Architect's Supplemental Instructions

Architect's ASI No: 018

Project:
Webster University
Interdisciplinary Science
Building

Date Issued: 08/19/2016

LEVEL 02 FLOOR
FRAMING PLAN

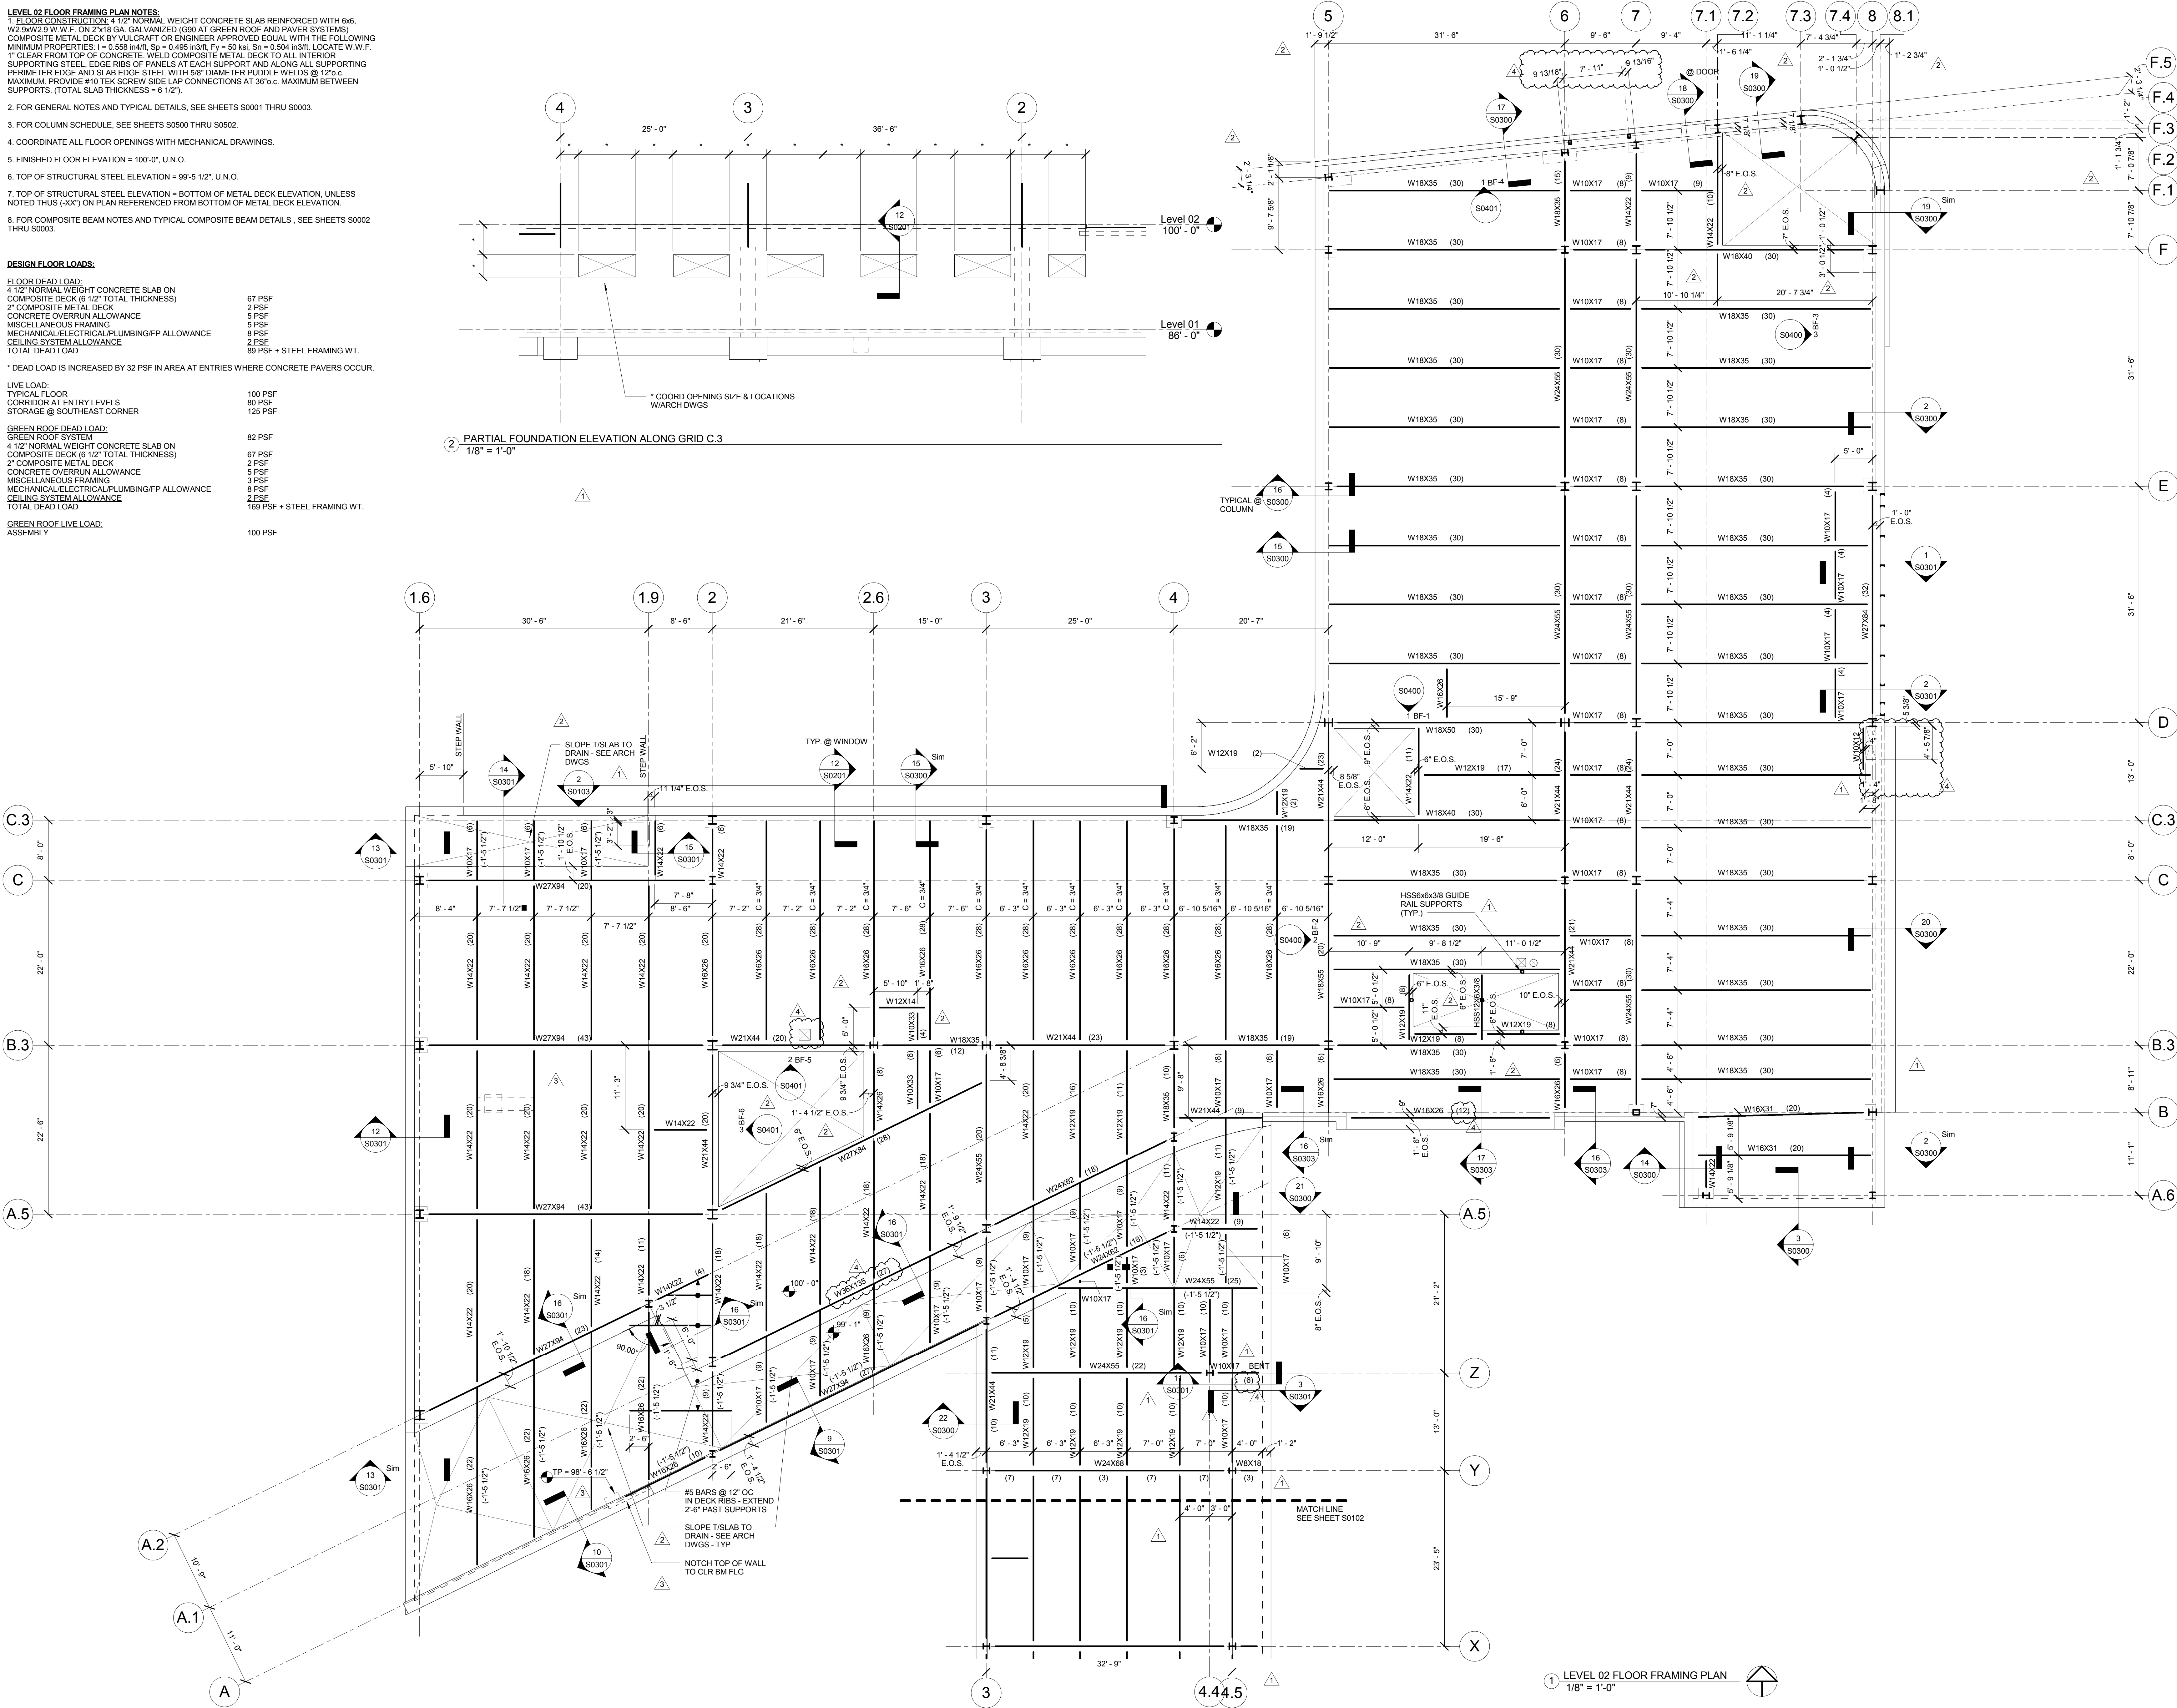
S0103:

Revisions to headed stud quantities, Beam size revision on Grid A.1, North window clarification, and opening revision/additions.

LEVEL 03 FLOOR
FRAMING PLAN

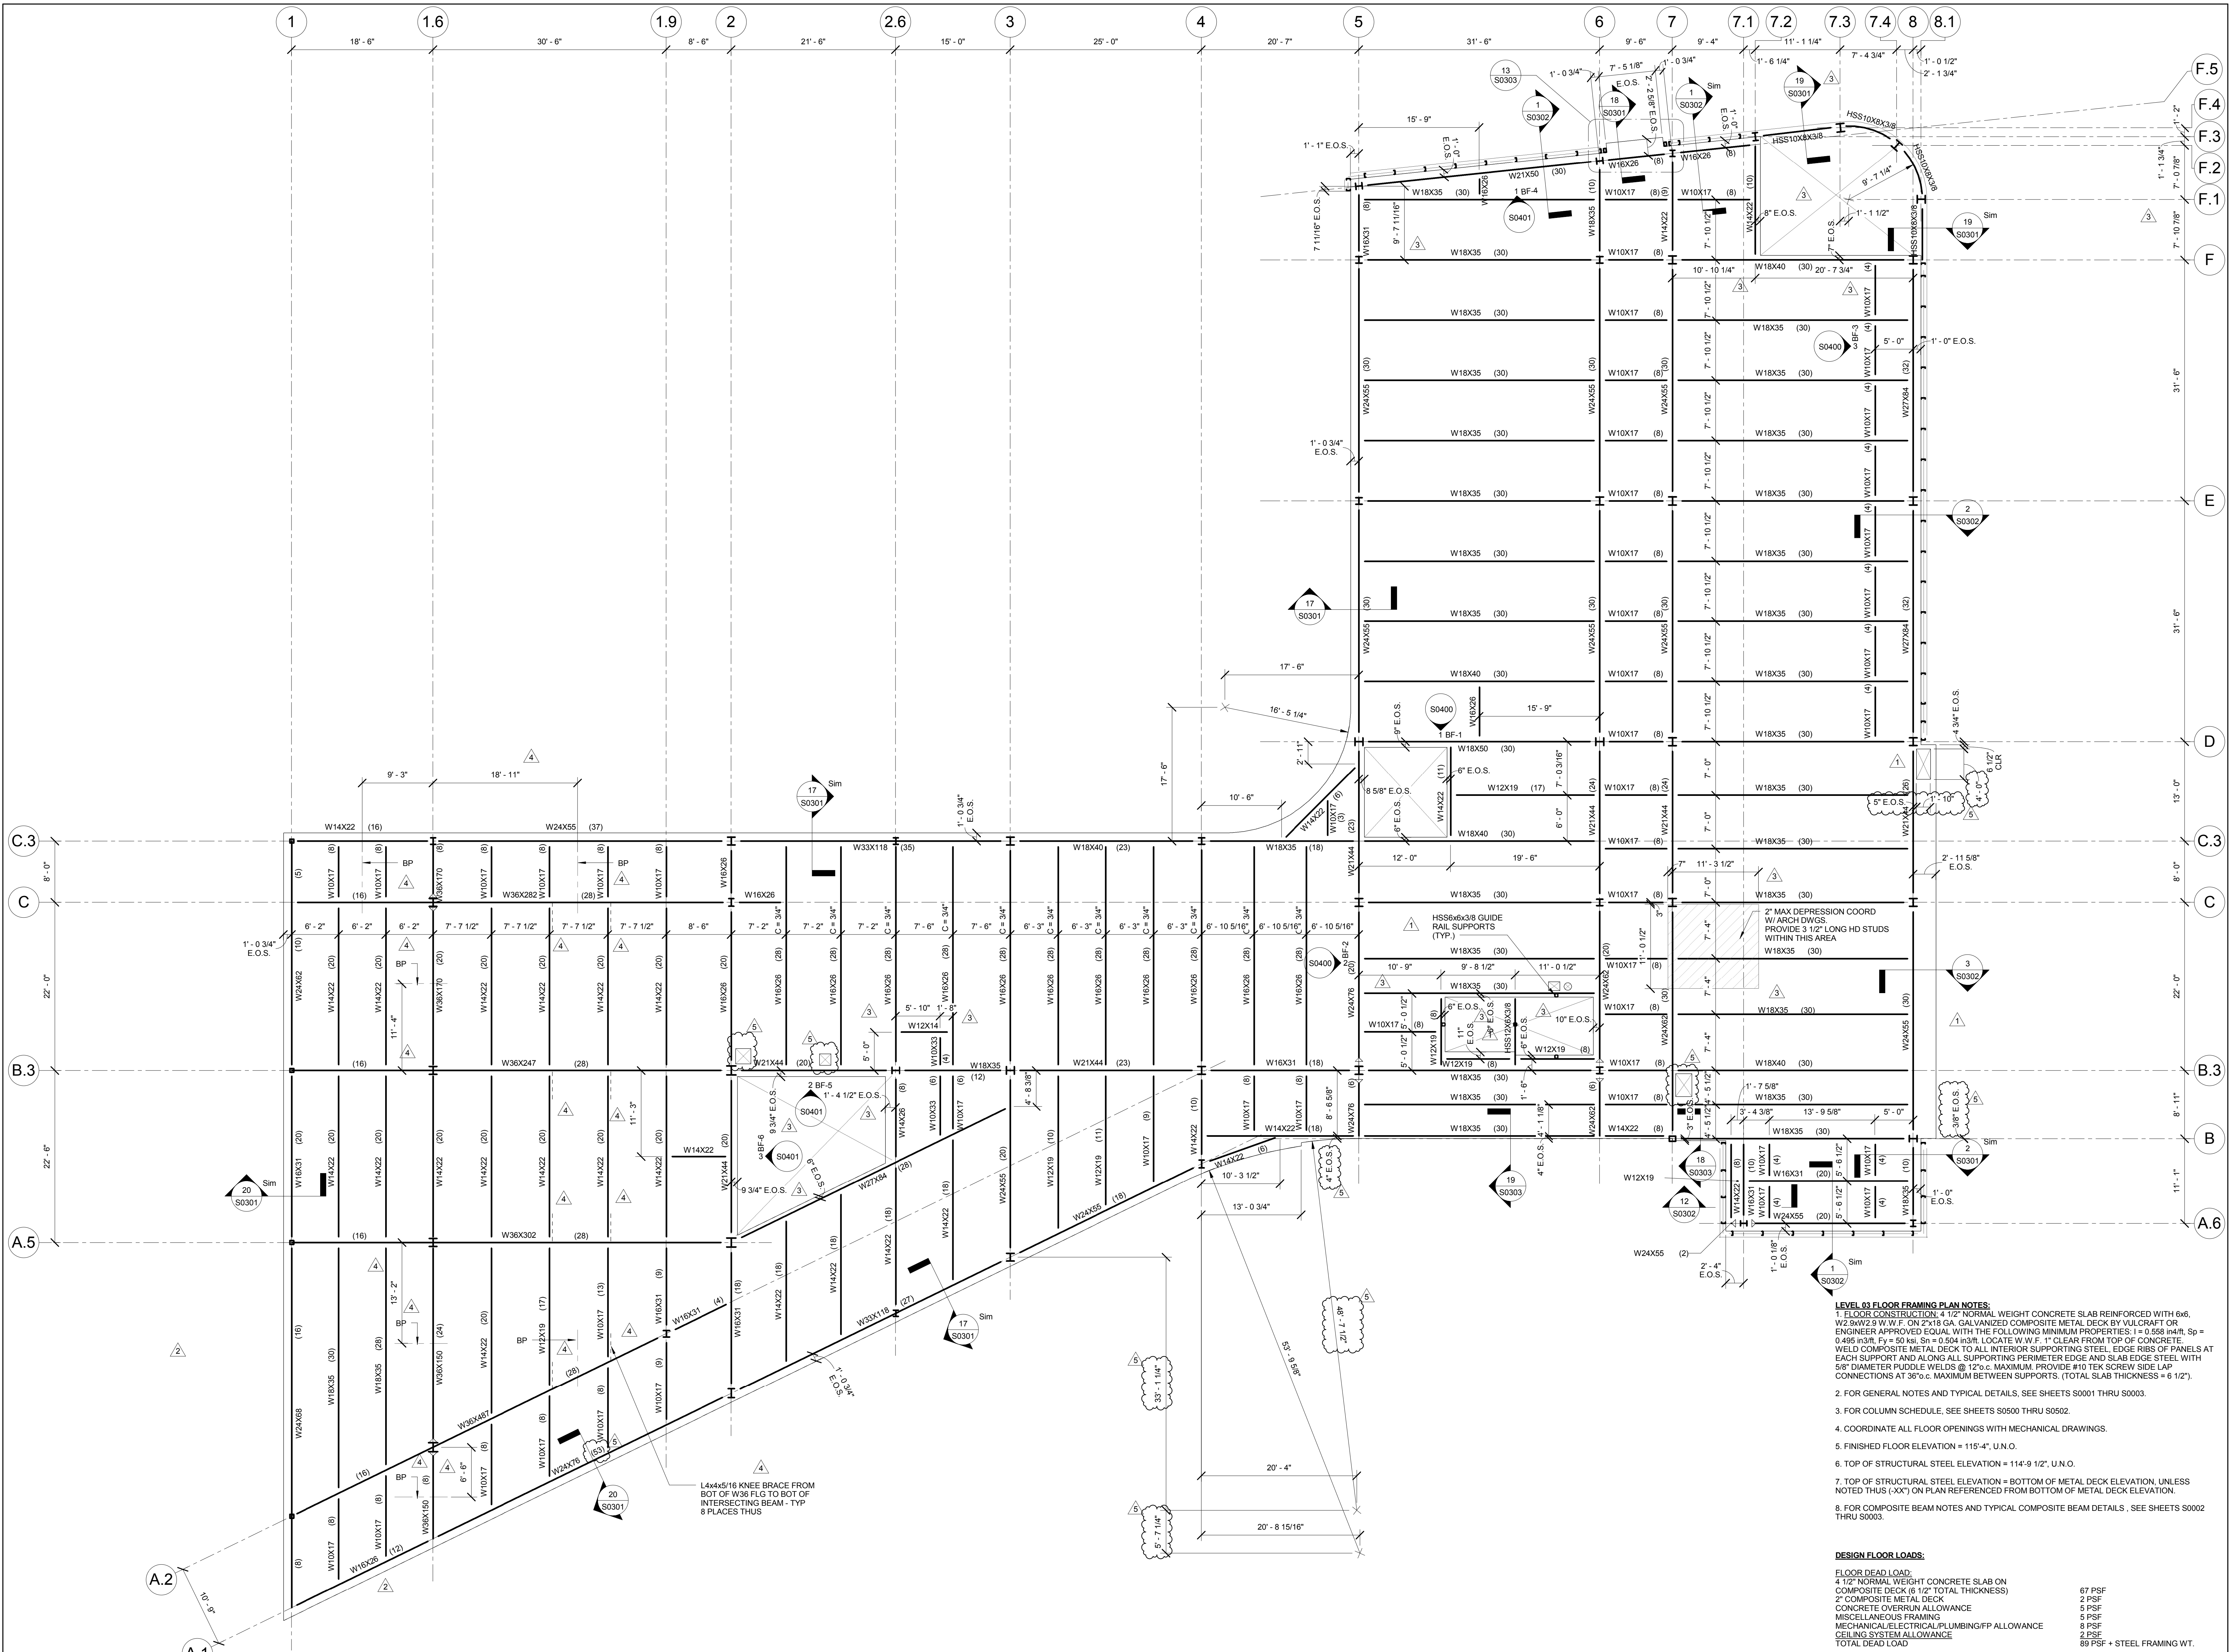
S0104:

Slab edge revision at Grid B, Dimensional revisions for south inside curve, Headed stud revision on Grid A.1, and opening revision/additions.

LEVEL 04 FLOOR
FRAMING PLAN

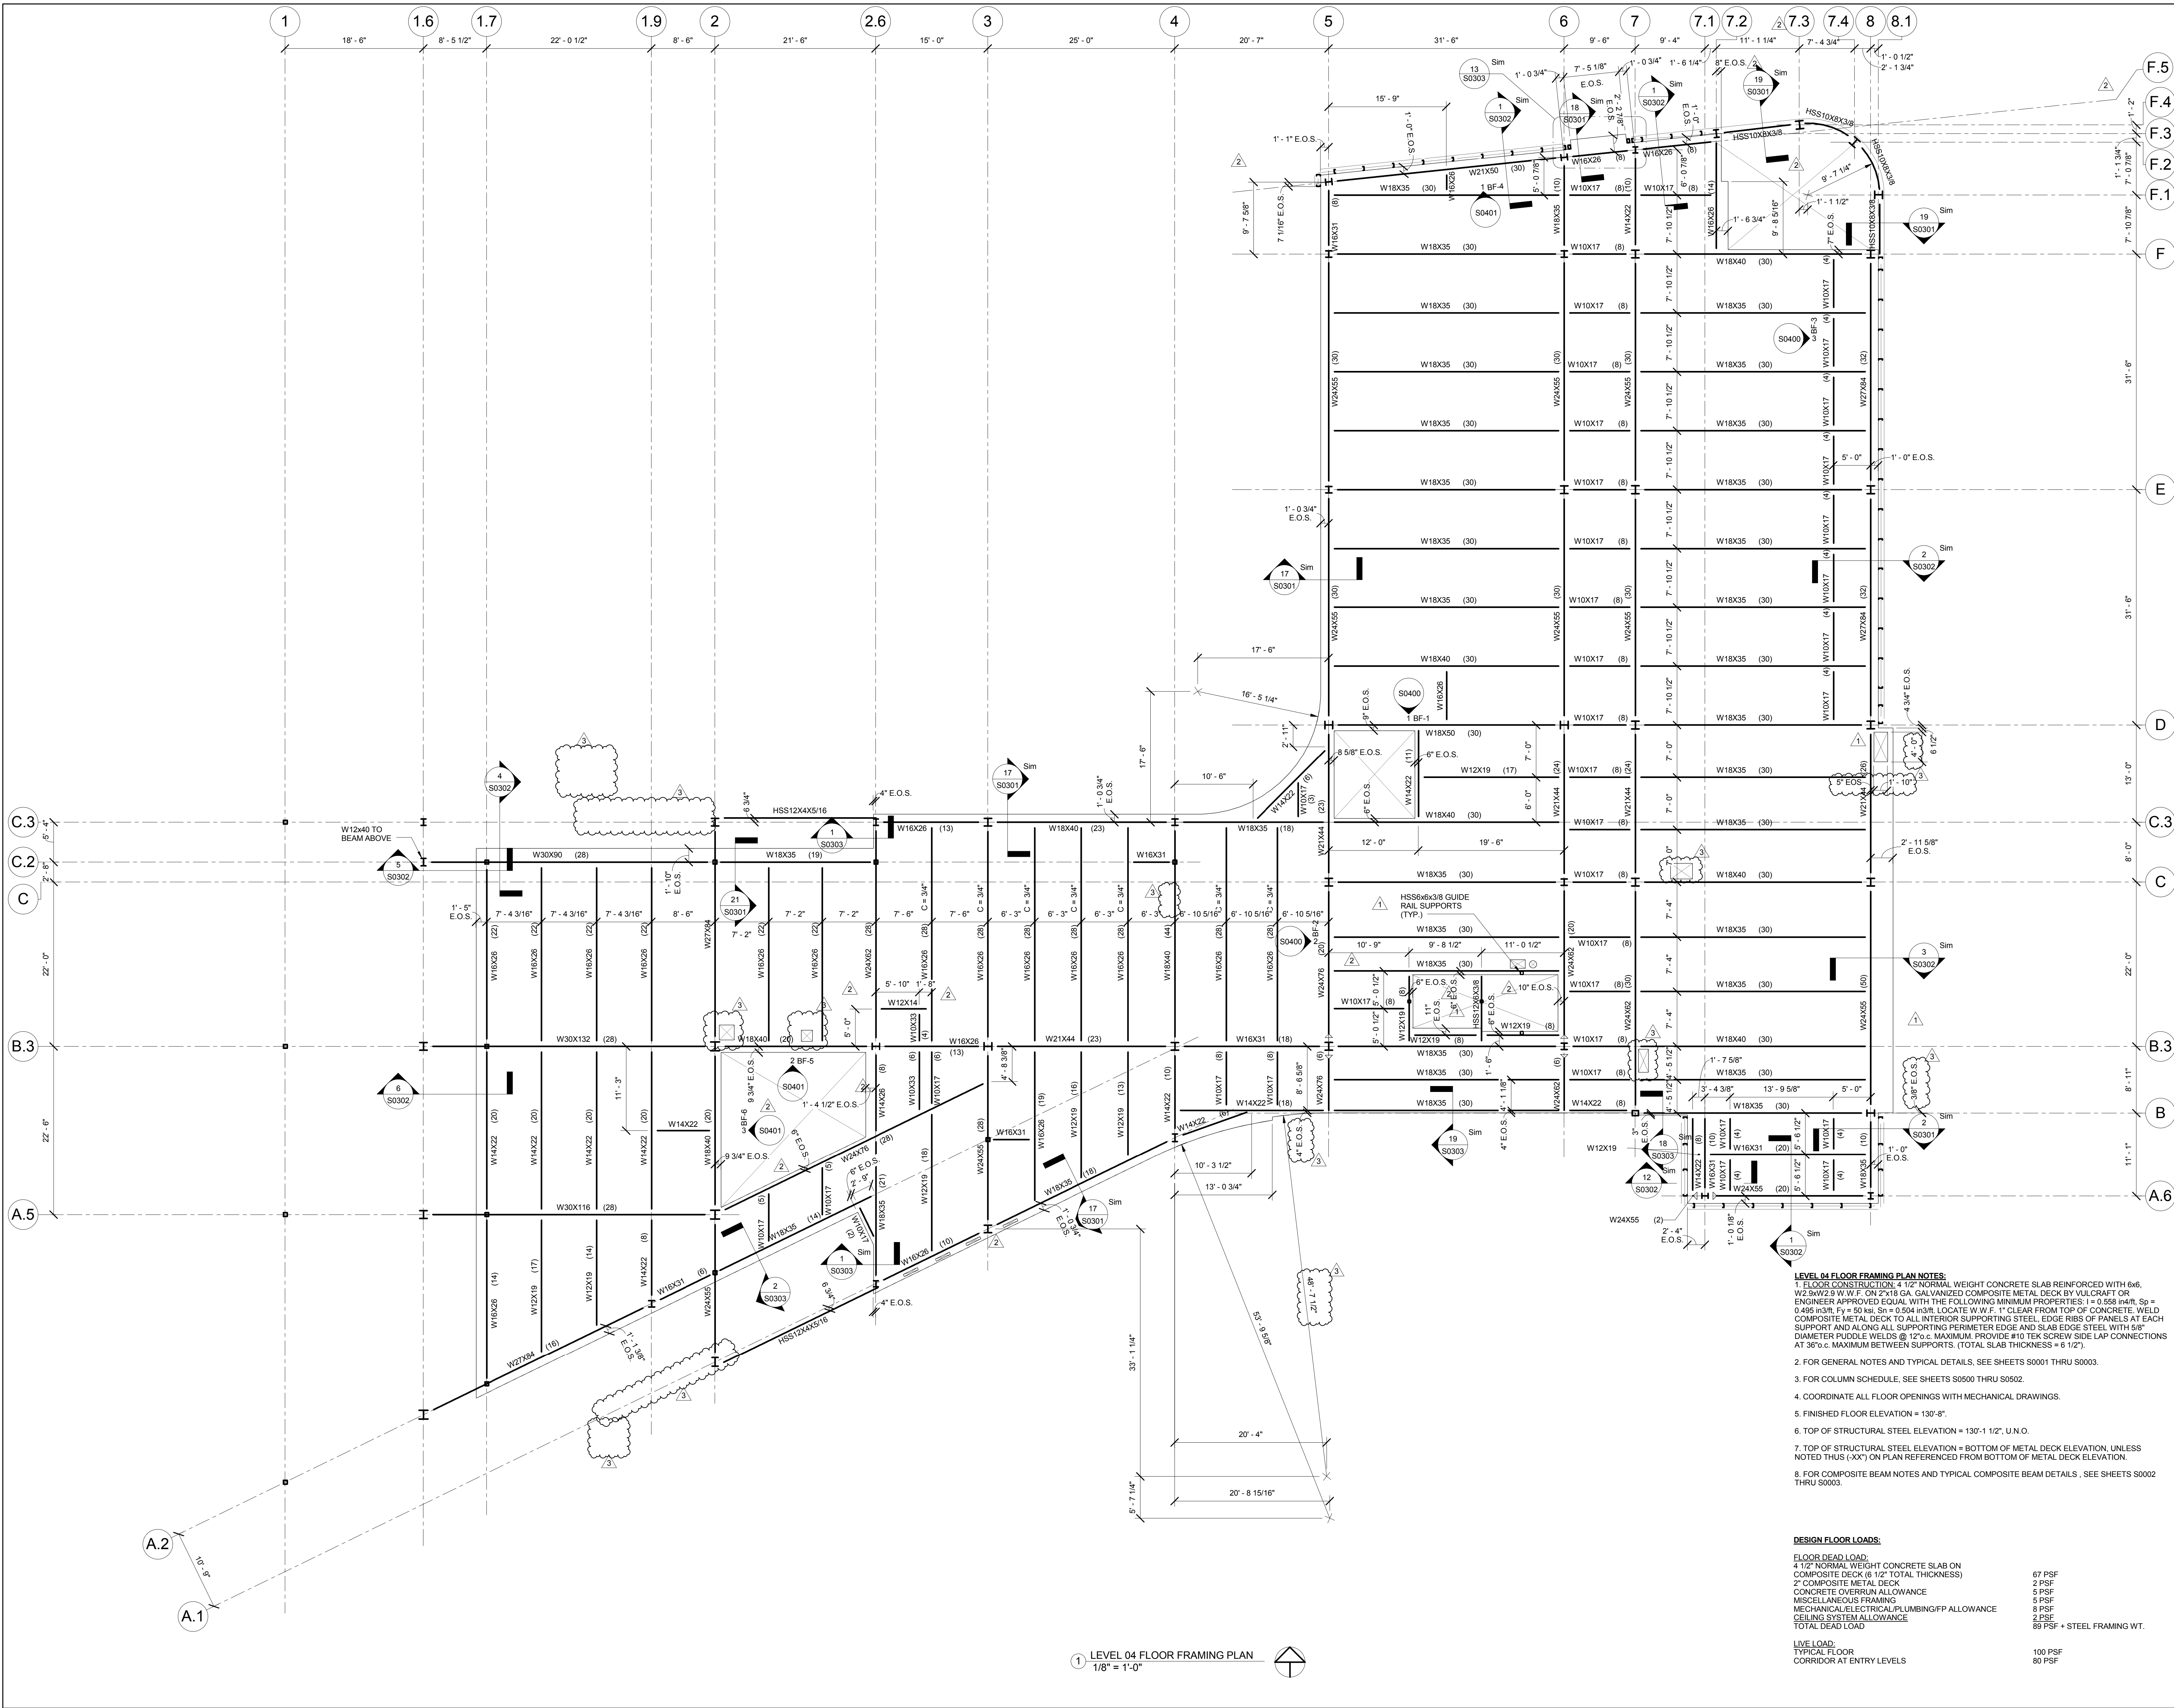
S0105:

Slab edge revision at Grid B, Dimensional revisions for south inside curve, Deletion of HSS girts and hanger framing between Grids 1.7 & 2, and opening revision/additions.
